**Section 16 Planning Application for Proposed Amendments to the Approved Master Layout Plan of Ma Wan Park Development at Ma Wan Lot Nos. 48, 114, 229 RP and 684 (Part) and Adjoining Government Land (Application No. A/I-MWI/48)**

**Responses-to-comments Table**

**Section 16 Planning Application for Proposed Amendments to the Approved Master Layout Plan of Ma Wan Park Development  
(Planning Application No. A/I-MWI/48)**

Broad Location of the Proposed Uses in Restyled Ma Wan Village

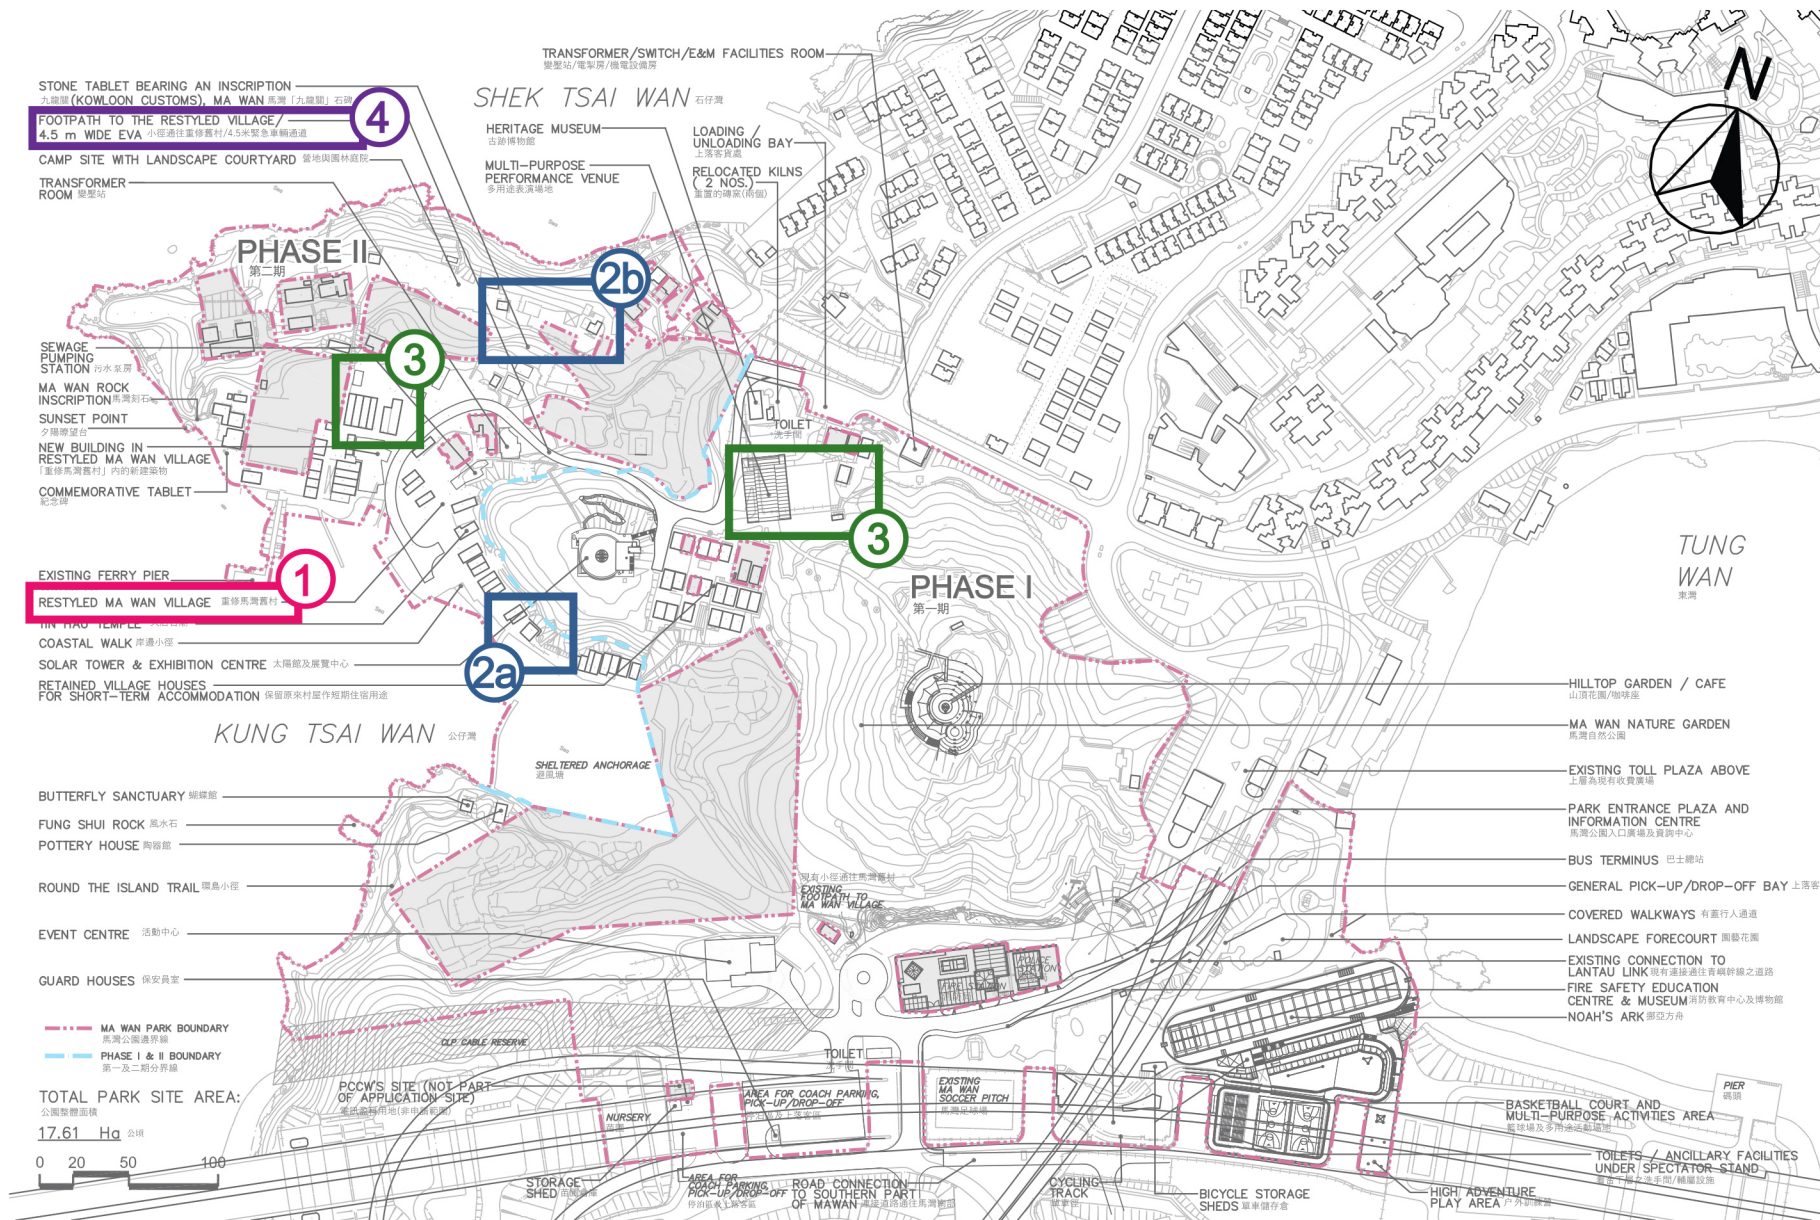
5.2	Figures 5 and 7 of the Planning Statement – As compared to the approved scheme, it is noted that apart from ‘Hotel (Holiday House)’ and ‘Place of Entertainment’ uses, ‘Holiday Camp’ use is also proposed in the village house area (i.e. green area) of the Restyled Ma Wan Village. Please elaborate and provide justifications for the proposed use in the Planning Statement with review on technical aspect as appropriate as it would increase the number of visitors staying overnight.	Please be clarified that the ‘Holiday Camp’ use should be within the green-dotted portion in the northern part only. The typo in the legend has been rectified (see revised Figures 5 and 7 of the Planning Statement in <b>Attachment 1</b> ).

Amendment Items:

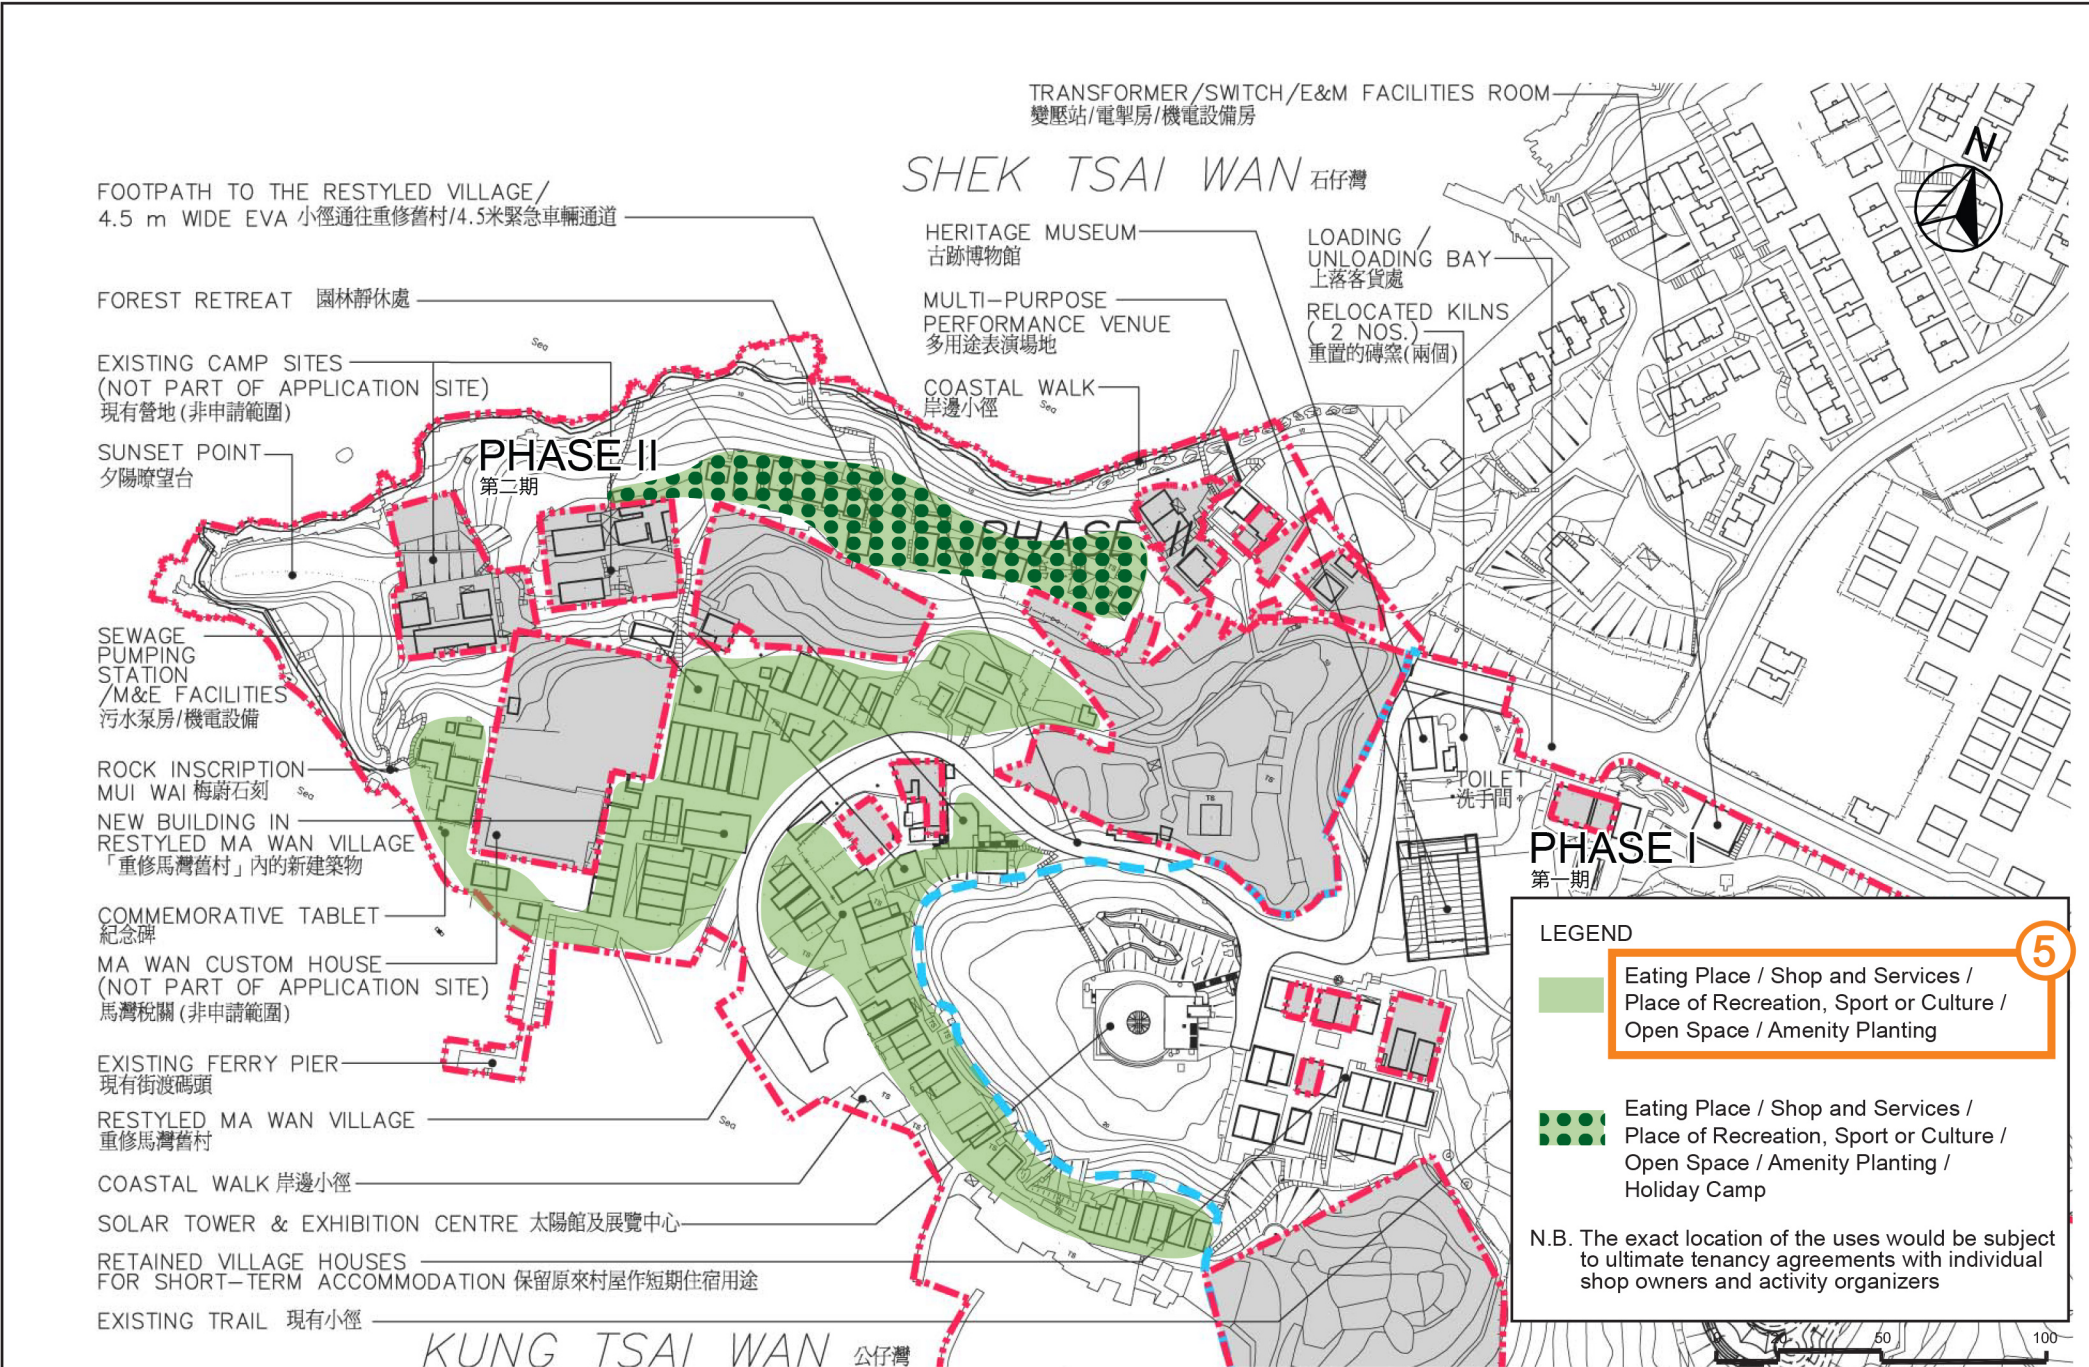
1.1	<p>According to Sections 1.1.2, 2.2 and 3.2.1 of the Planning Statement, the site boundary has been updated in relation to the approved Planning Application No. A/I-MWI/45. Please indicate the changes of the site boundary between the two planning applications in the relevant figures as appropriate.</p>	<p>Please refer to Figure 6 for a comparison between the Proposed and Approved Master Layout Plan under Planning Application No. A/I-MWI/45) (see <b>Attachment 1</b>). The updates to the application site boundary by excluding two unacquired lots, i.e. Lots 241 and 244 in Ma Wan, and avoiding minor encroachment into an area covered by Government Land Licence, are illustrated in Items 2a and 2b of Figure 6.</p>

Departmental Comments	Responses to Comments
<b>5.</b>	<b>Comments of Planning Department – District Planning Office</b>	
5.1	Item 3 of Figure 6 of the Planning Statement – There is a typo (i.e. “General update of the base map to reflect the existing/building structures”). Please omit the “/”.	The typo has been rectified accordingly (see revised Figure 6 of the Planning Statement in <b>Attachment 1</b> ).

- ① Include short-term accommodation purpose in the annotation for Restyled Ma Wan Village
- ②a Update the application site boundary by excluding two unacquired lots, i.e. Lots 241 and 244 in Ma Wan

②b avoiding minor encroachment into an area covered by Government Land Licence
- ③ General update of the base map to reflect the existing building structures

④ Include access in the annotation for footpath to the Restyled Village / 4.5m wide EVA

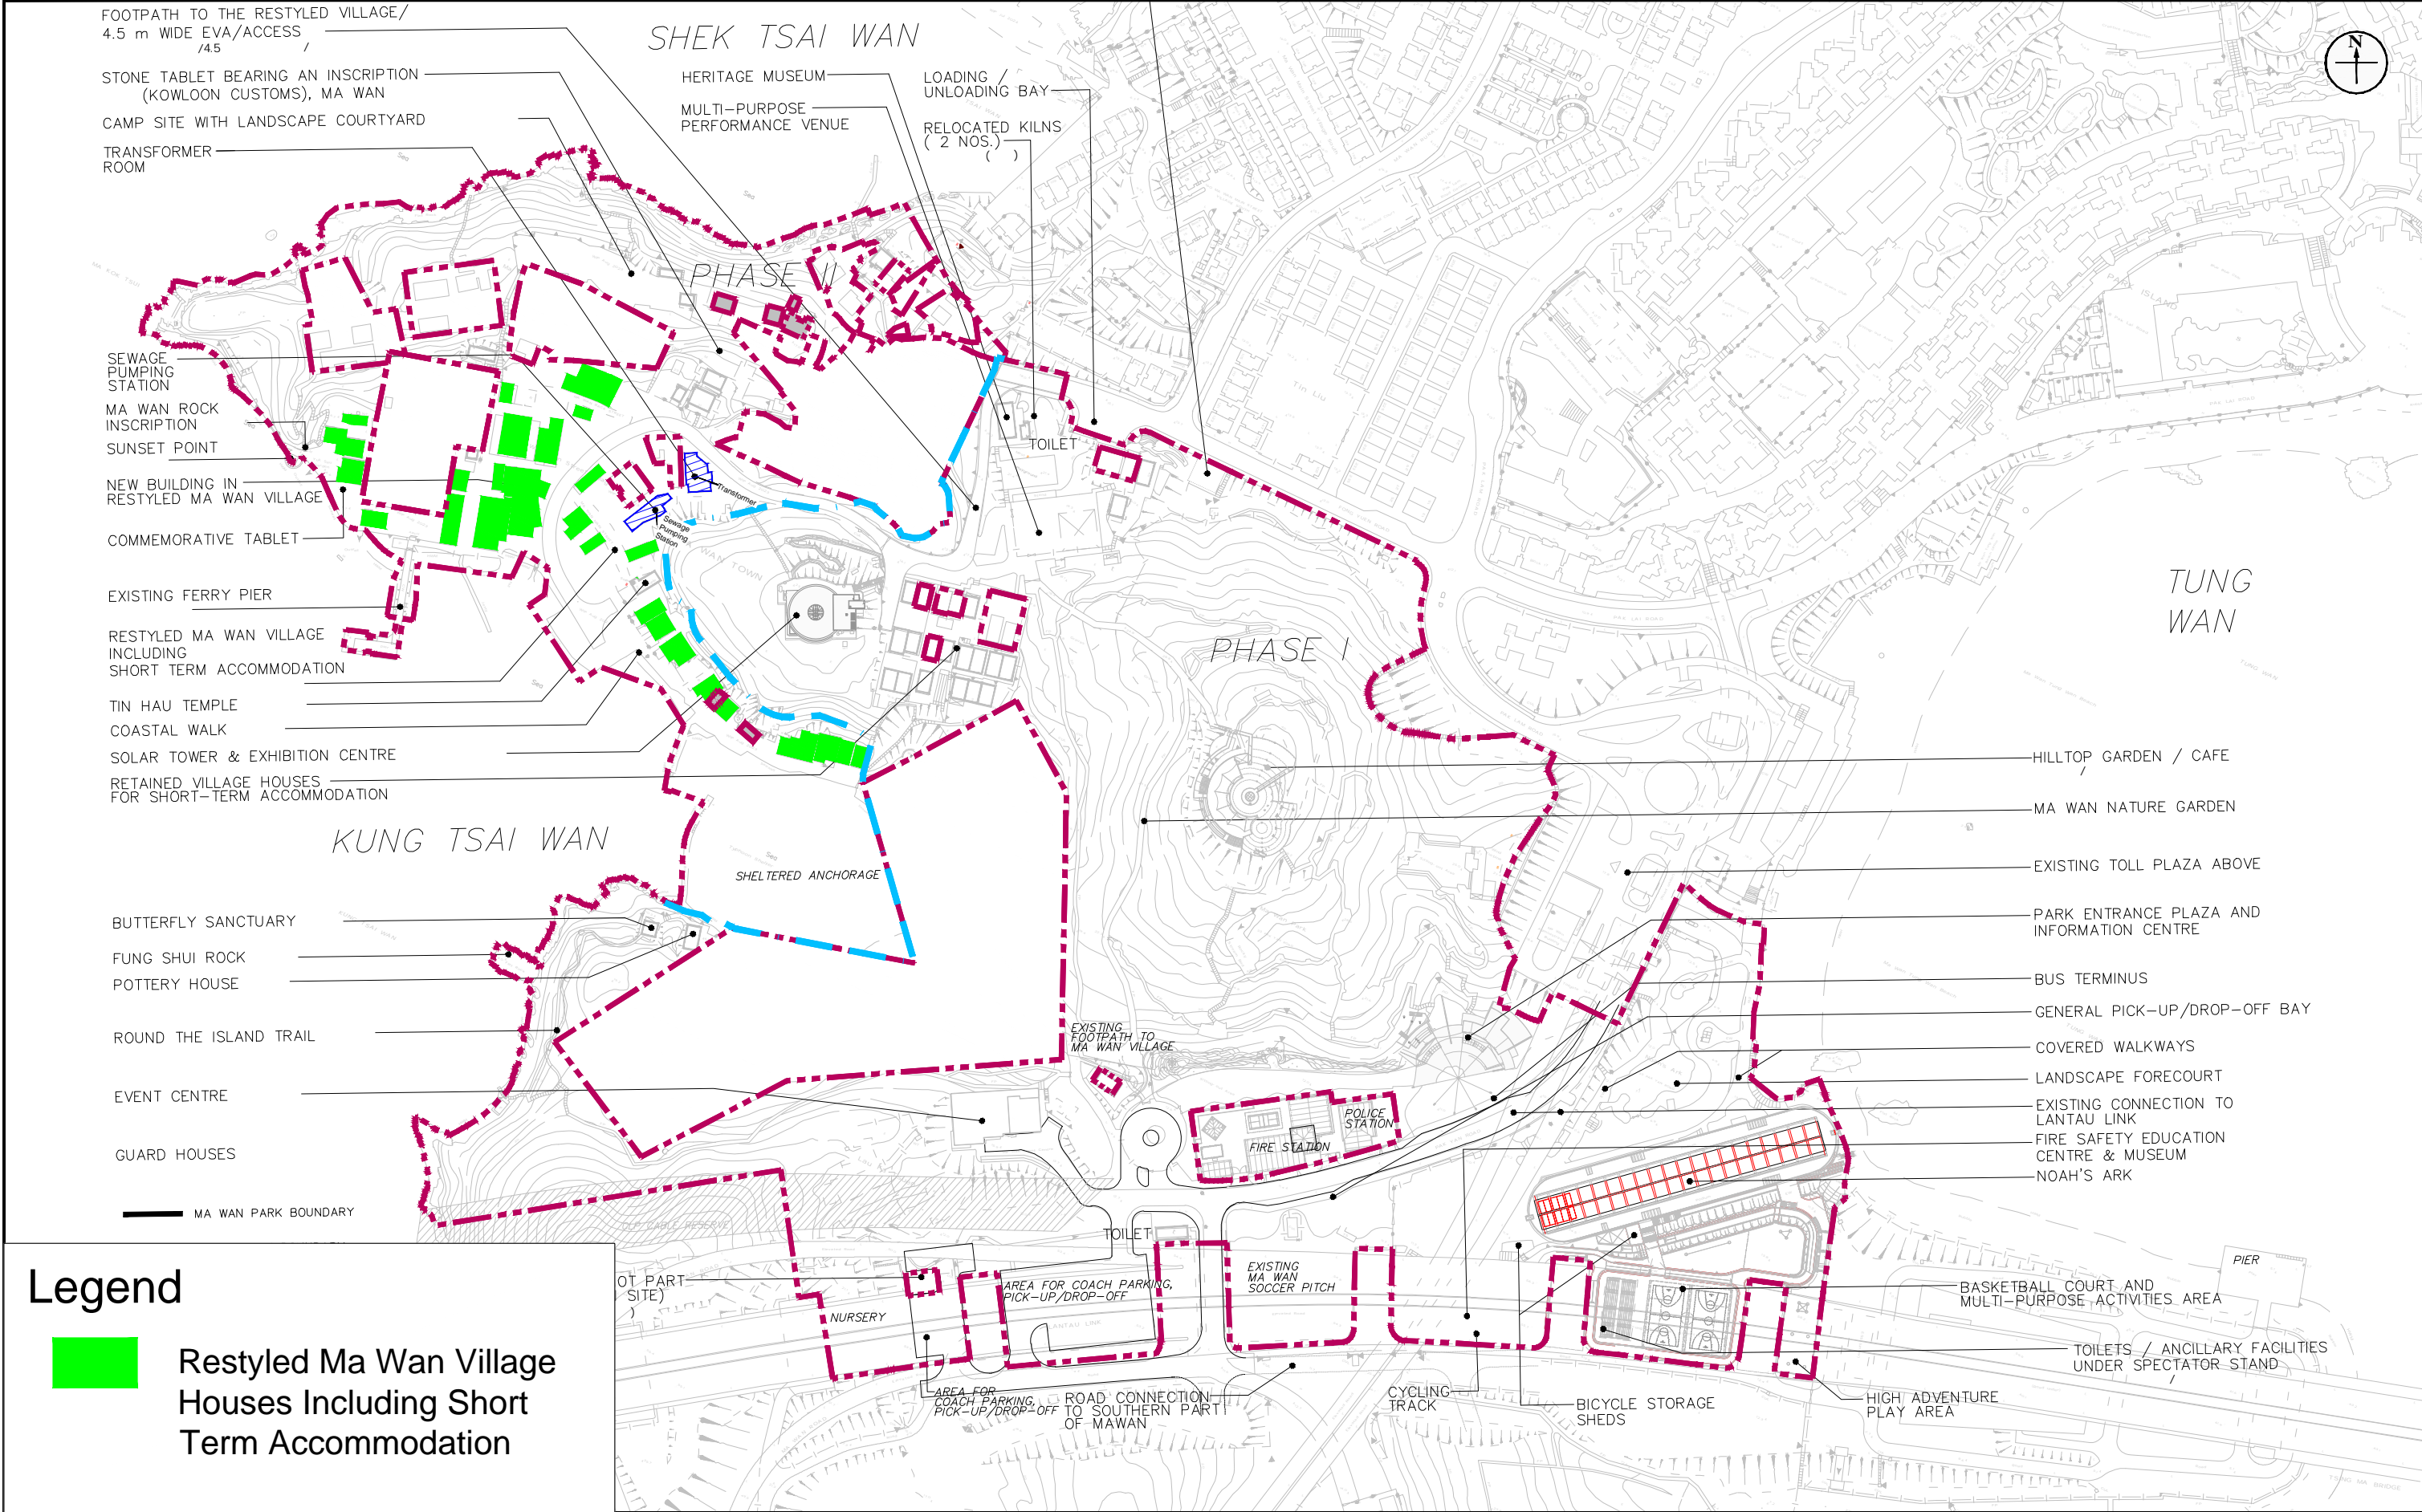
1.2	<p><b><u>Tin Hau Temple (Grade 3)</u></b></p> <p>The Tin Hau Temple (Grade 3) is indicated as “<u>Restyled Ma Wan Village Houses including Short Term Accommodation</u>” in Figures 1-1, 2-1, 3-1, 4-1 and 5-1 of Appendix E of the Preliminary Environmental Review of the current pre-submission. However, according to the accepted Preservation and Restoration Proposal for Tin Hau Temple, Ma Wan (November 1, 2023 version), which contributed to the partial fulfilment of approval condition (n) under Planning Application No. A/I-MWI/45, Tin Hau Temple will be <u>kept empty and opened to public for appreciation</u>.</p>	<p>Please note that it is an editorial error to include Tin Hau Temple as “Restyled Ma Wan Village Houses including Short Term Accommodation”. Figures 1-1, 2-1, 4-1 and 5-1 of Appendix E of the Preliminary Environmental Review have been revised to exclude the Tin Hau Temple accordingly (see <b>Attachment 2</b>). Please also note that Figure 3-1 as mentioned in paragraph 2.2.2 of the Preliminary Environmental Review is a typo. It shall refer to “Figure 2-1” instead. The replacement page has also been provided in <b>Attachment 2</b>.</p> <p>Please be clarified that the Tin Hau Temple will be kept empty and opened to public for appreciation in accordance with approval condition (n).</p>
